ONSITE SANITATION City of Portland – Bureau of Development Services 1900 SW 4th Avenue, Portland, Oregon 97201 – 503-823-7300 – septic@portlandoregon.gov SEPTIC REVIEW CERTIFICATION

SMITH RESIDENCE

MITH RESIDENCE CORBETT OREGON

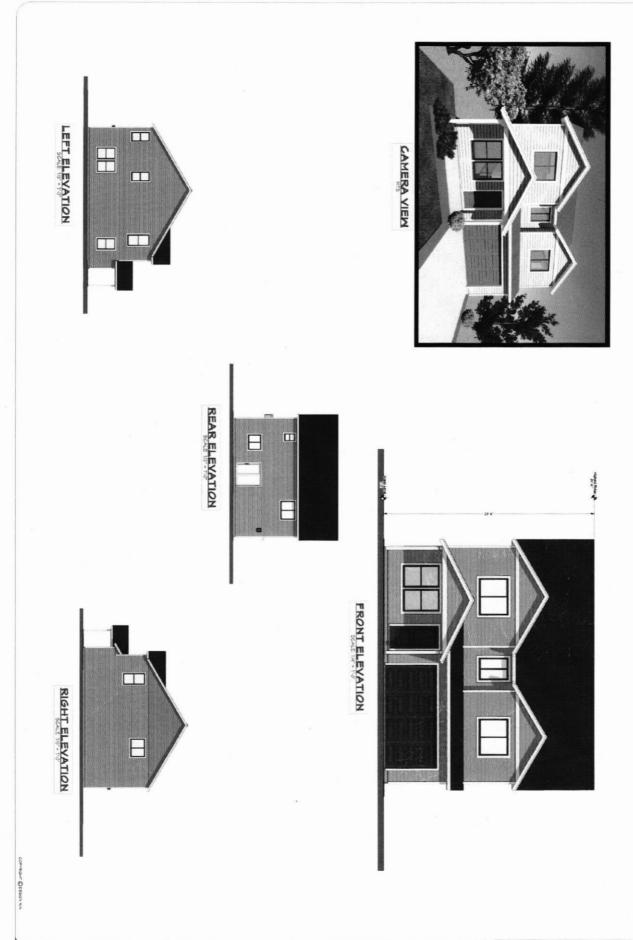
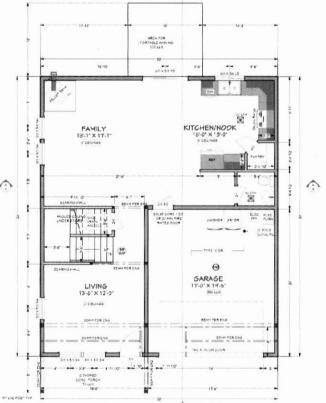
Submit complete Septic Review Certification submittal package via:	R
E-mail septic@portlandoregon.gov. Information will be provided to make payment online OR -	19
Mail completed submittal package and check payable to City of Portland to: City of Portland, BDS, Site Development, 1900 SW 4 th Ave., Portland, OR 97201	2
	ı
STEP 3- Review: After submittal and payment, allow up to 20 business days for plan review	
STEP 4- Site Visit: Sanitarian will contact you with any questions and/or site visit requirements	
STEP 5- Sign Off: Based on present knowledge of the area and current regulations of the State of Oregon Department of Environmental Quality (DEQ), the Sanitarian hereby finds that the above proposal is:	
Approved – will not impact the existing system. The following is REQUIRED prior to Building Permit issuance:	
☐ Septic Installation Permit ☐ Authorization Notice	
Conditions/Comments: Proposed 3-bedroon replacement dwelling to connect	t

to existing septic system poses no concern to septic. Site visit	-
completed under previous Authorization Notice #20-212716-SE proposal	-
(abandoned for annest proposal) + new septic "instanced/inspected inde	
21-024260-St. Current Authorization Nonce must be issued prox to building	8
Multnomah County Sanitarian Walks FETS 318/24 Date	
iviationali County Salitarian
